NEW HANOVER COUNTY FINANCE DEPARTMENT

ADDENDUM # 1

From: Lena L. Butler, Purchasing Supervisor
To: All Bidders
Project: MRF Improvements-RFB # 15-0359
Date: June 15, 2015

New Hanover County Recycling
 3002 US-421
 Wilmington, NC
 PROJECT DESCRIPTION: REPAIR PLAN & RISER ROOM
 DRAWN BY: D.N.U. DATE: 05-29-2015
 PROJECT NO: 15060
 DESIGNED BY: W.D.J.

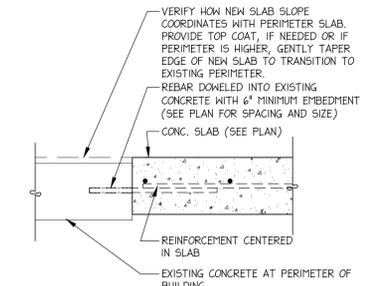
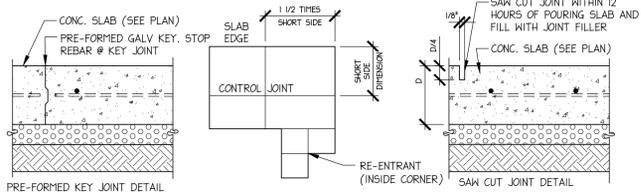
6. Corrections/Clarifications to plans:
The inside pit will require at least 32 feet of structural fill for half the length of the pit and 14 feet of structural fill for the second half, it appears that the bottom of the pit is reinforced concrete slab with some water, little debris, and muck. All of this material will need to be removed in order to place the fill. Please note that the structural general notes for backfill lists the fill to be placed in 4 foot lifts (4'), this should be 1 foot lifts (1') – plans have been revised. Also S&ME will be on site on a full time basis observing the fill placement and performing compaction testing per the general notes and statement of SI.
